MEMORANDUM

From:	Built Heritage Officer		
Service	Green Infrastructure	App No:	261134
Address:	The Courtyard, Town Hall, Market Place, Wokingham, RG40 1AS.		
Proposal:	Application for Listed Building consent for the proposed installation of two roof-mounted air source heat pump condenser units and associated plant, together with the erection of a roof-level fall-prevention guardrail at The Courtyard, Town Hall, Market Place, Wokingham.		
Heritage Asset:	The Town Hall – Grade II* since 1969 Wokingham Town Conservation Area Setting of: 3 and 4, Market Place – Grade II 5 Market Place – Grade II 6 Market Place – Grade II* Roebuck Public House, Market Place – Grade II Fosters, Market Place – Grade II K6 Telephone Kiosk, Market Place – Grade II Drinking Fountain, Market Place – Grade II Ye Olde Rose Inne – Grade II Red Lion Public House – Grade II* 22 Market Place – Grade II 23 and 34 Market Place – Grade II Listed buildings, along with conservation areas, are classed as being designated heritage assets under the NPPF (2024) and in the Council’s Local Plan policies

Aerial photograph of courtyard roof,

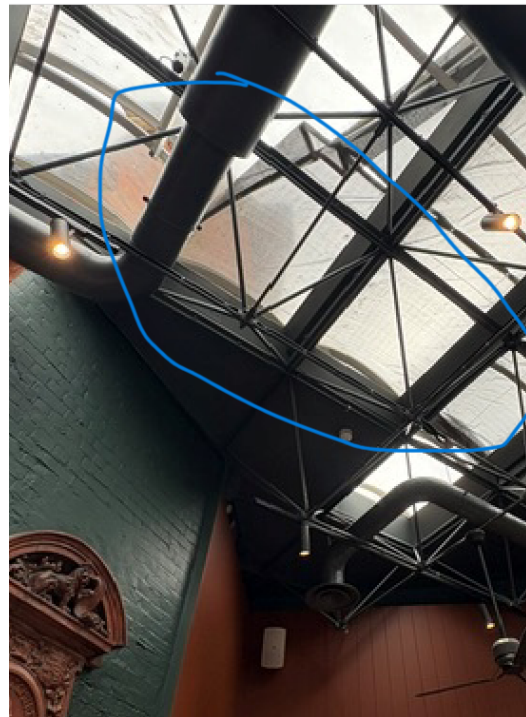
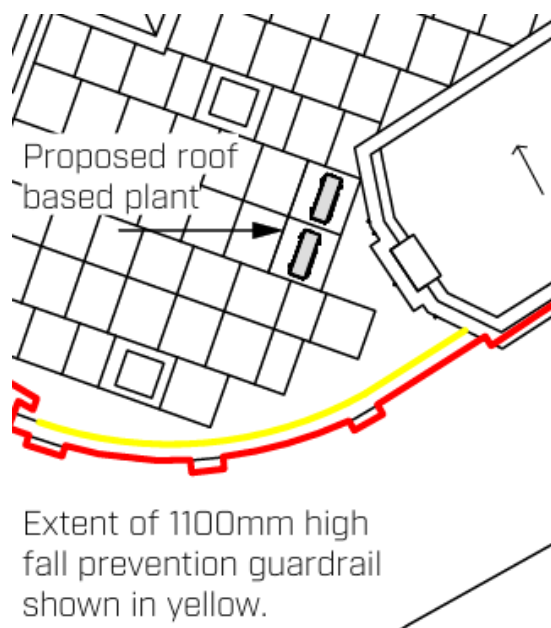
Location on roof for the ASHP as shown by blue line in photo

Courtyard roof raised Perspex lights. Top line of the parapet upstand around courtyard circled in blue. The 2no. Perspex rooflights (one covered in black cloth) would be where ASHP to be situated.

I speculate that course of black bricks to the left of the image that is in line with the end of the blue line highlight the parapet upstand is the same course of brick in the photos between, on the Town Hall that runs two courses of brick above the coping to the top of the Courtyard walling.
